Coal Combustion Residuals Landfill Composite Liner Design Certification

Leland Olds Station Landfill

Prepared for
Basin Electric Power Cooperative

Prepared by
Barr Engineering Co.

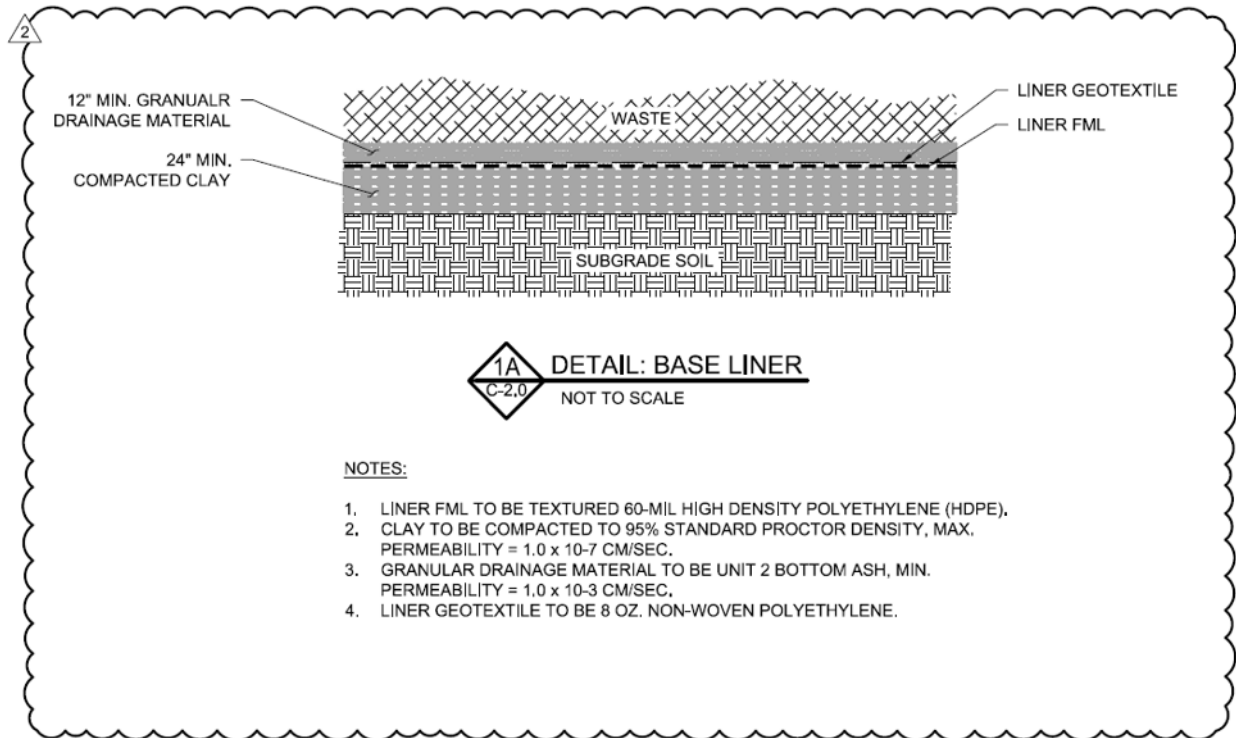
As Basin Electric constructs additional cells at the Landfill, the design for the leachate collection system (LCS) has been updated to omit a geotextile (filter fabric) above the sand/bottom ash granular drainage layer. The purpose of this report is to document the liner and leachate collection and removal system design for the lateral expansion at LOS meets the minimum requirements as set forth in § 270.70(a), § 257.70(b) and 270.70(d). This minor change is the only modification that is being proposed as part of this certification.

- 12-inch drainage layer
- Protective geotextile
- 60-mil high density polyethylene (HDPE) geomembrane barrier layer (Liner FML)
- 24-inch compacted soil barrier layer
- Prepared subgrade
